**Subject: Stormwater Management Permit - Revisions
49 Asbury Street
(Assessor's Map 28, Lot 6)**

Work is ongoing. The Applicant requests the following plan changes:

Stormwater Management Report

**July 2, 2025
(Revised 7/31/25 & 7/7/26)**

DR-2

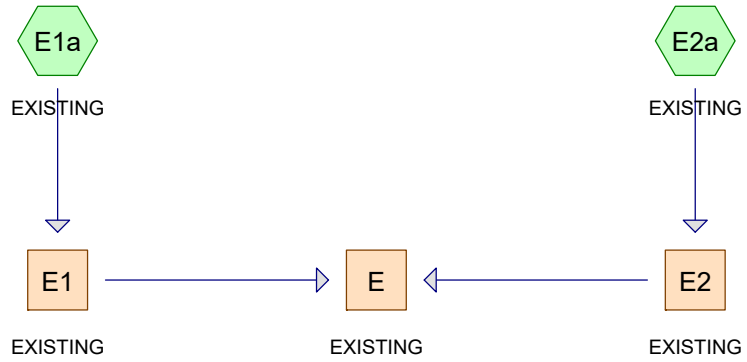
No.	Date	Description
1	7/31/25	ADD BMP ANNOTATIONS.
2	7/7/26	RELOCATE INF. FIELDS
